# MIAMI BEACH

### Staff Report & Recommendation

### Design Review Board

SUBJECT: **DRB19-0462**  
**6961-6985 Abbott Avenue, 300-326 71<sup>st</sup> Street, and 6972 Harding Avenue**

Permit 86228, City National Building east elevation  
(along Abbott Avenue)

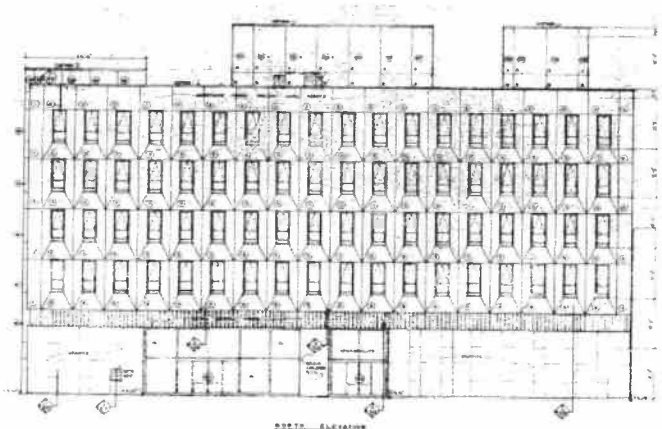
Although the plans submitted by the applicant for the existing buildings are generally undetailed, the floor plans identify each level ambiguously as "commercial". In order to retain the existing building and benefit from the variances supported by staff, it is still recommended that the architect in the future redesign the ground floor component of the City National Bank building to incorporate a more active use that will better engage the street and sidewalk along the 71<sup>st</sup> Street corridor. However, staff understands that the current use in a longstanding tenant and has substantial time remaining in the contract lease.

Prior submittal, "drive through" nature of ground floor

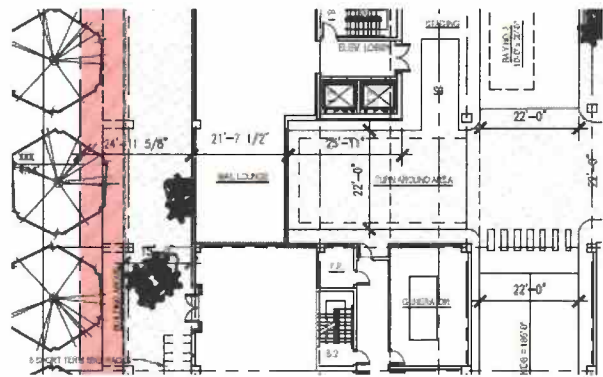
Staff has worked closely with the architect, specifically as it pertains to the ground floor site plan, to prioritize the important areas of the frontages in this unique geometrical site that will most successfully activate a vibrant street atmosphere and promote pedestrian activity.

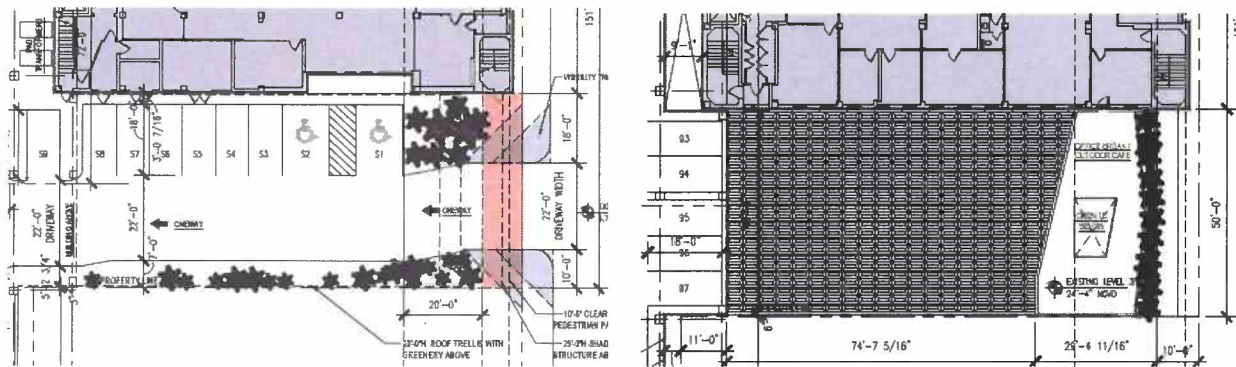
wall plane. This lower level aligns with the elevation height of the neighboring Gidney building. The screening along the upper levels of the garage exhibits a diminutive pattern of the

The tower contains floor to ceiling glass along its expansive east and west elevations, and feature projecting glass balconies that stagger at every other floor and extend past the tower's vertical walls. The cantilevering of the balconies coupled with their staggered rhythm, lends the glass façades movement and interest. In contrast, the slender, north and south elevations are predominately finished in white stucco with vertical ribbons of fenestration and compliment the prominent elevations. The project extends to Harding Avenue, with the site south of the City National Bank proposed as the singular vehicular entrance and a surface parking lot, covered with a terrace and trellis.

Prior submittal showing "drive through" nature of ground floorplan

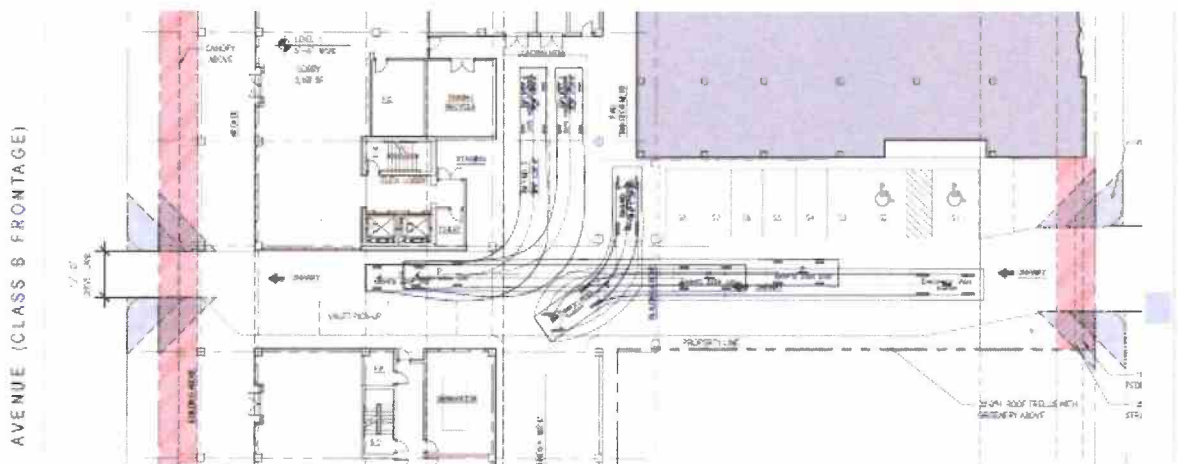
The applicant has removed both of the waivers to allow a driveway on Abbott Avenue (a Class B street) when Harding Avenue (a Class C street) frontage permits a combined driveway and to have multiple driveways. The subject site is part of combined Blocks E and 12 which spans from 69<sup>th</sup> Street to 71<sup>st</sup> Street and which were historically platted without a 70<sup>th</sup> Street crossing right-of-way. The total length of this super block measures 601'-4" in length.

Staff was strongly opposed to the previous proposed ground floor site plan, as it included the total retention of the existing surface parking area and necessitated driveway waivers and variances for a drive through scheme onto the Class B street (Abbott Avenue).

Revised submittal showing singular driveway entrance and 'wooner' plaza nature of ground floorplan

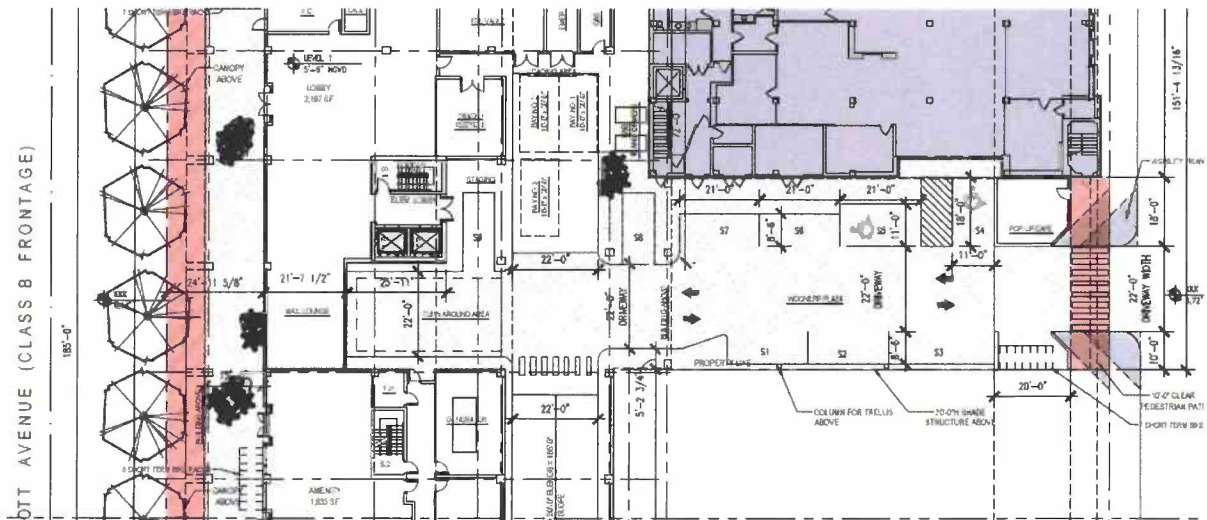
The revised proposed site plan repurposes the existing surface parking area behind the CNB building and restripes it for parking. The revised plan also creates a covered trellised area and an upper terrace area for the employees of the CNB bank building, and adds a new retail space along Harding Avenue.
